BCA Assessment Report

Schematic Design – REF Submission
World Class End of Life Program
Wyong Hospital

Prepared for:
Health Infrastructure

Revision 2
26 March 2024
Reference: 230224

Figure No. 3 – Required fire separation of the Class 4 Overnight Bedroom

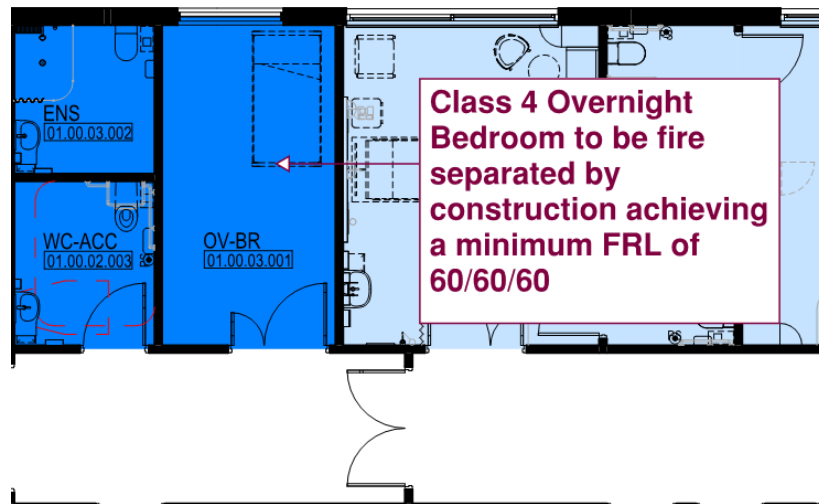
A Class 4 part of a building requires the same FRL for building elements and the same construction separating the Class 4 part from the remainder of the building as Class 2 part in the same Type of Construction.

In this instance, the Class 4 overnight room is required to be separated from the remainder of the storey by construction which achieves a minimum FRL of 60/60/60.

Figure No. 8: Solid core door required to be provided to overnight room

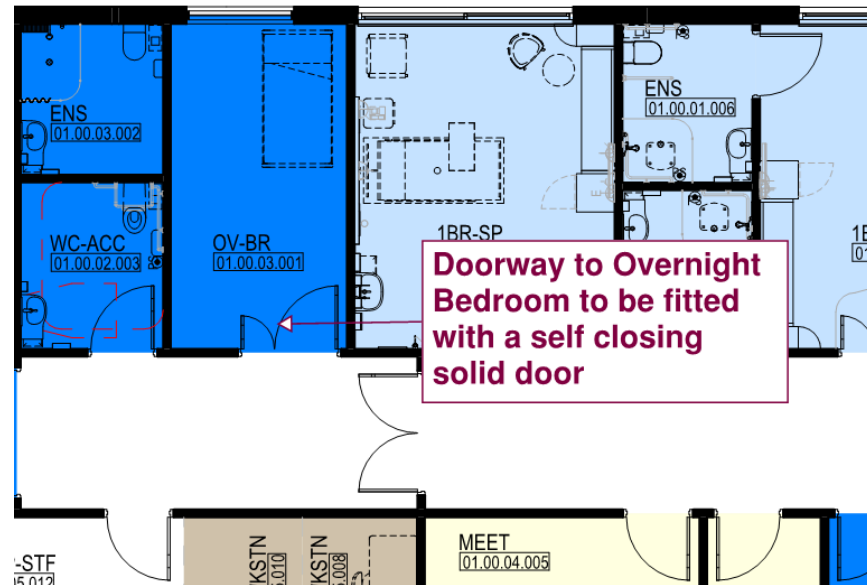
The doorway leading to the Class 4 overnight bedroom is required to be protected by a self closing, tight fitting, solid core door, not less than 35 mm thick.
